HEWLETT PACKARD

MANUAL CHANGES

MANUAL DESCRIPTION	
INSTRUMENT:	59301A ASCII to Parallel Converter
SERIAL PREFIX:	1328A
DATE PRINTED:	AUGUST 1973
HP PART NO:	59301-90003

CHANGE DATE: February 26, 1975

Page 8-5, Figure 8-3, 59301A schematic:

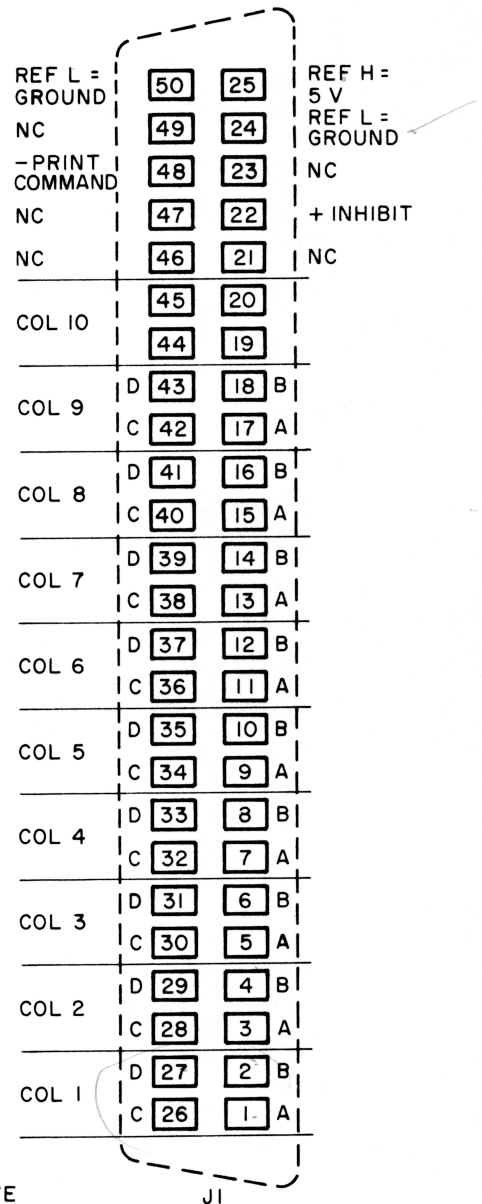
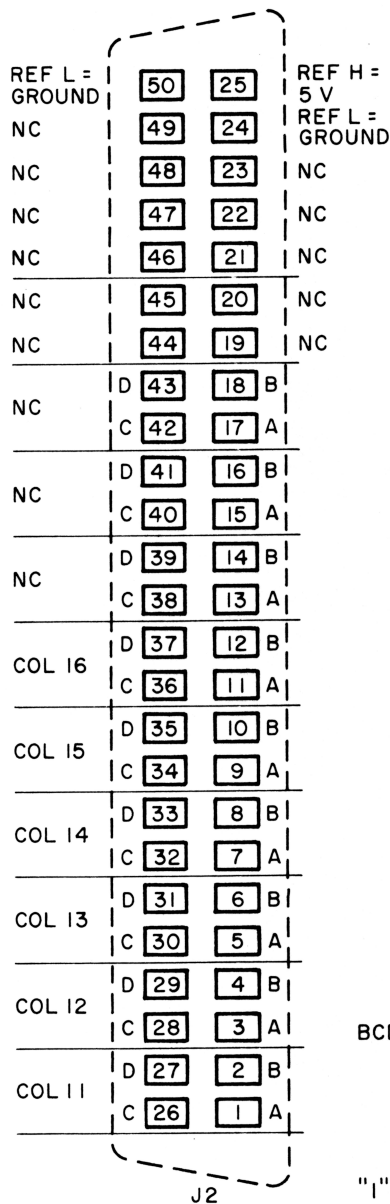
Add to schematic the following J1 and J2 connector drawings — also see Page 3-2, Figure 3-2 for connector location.
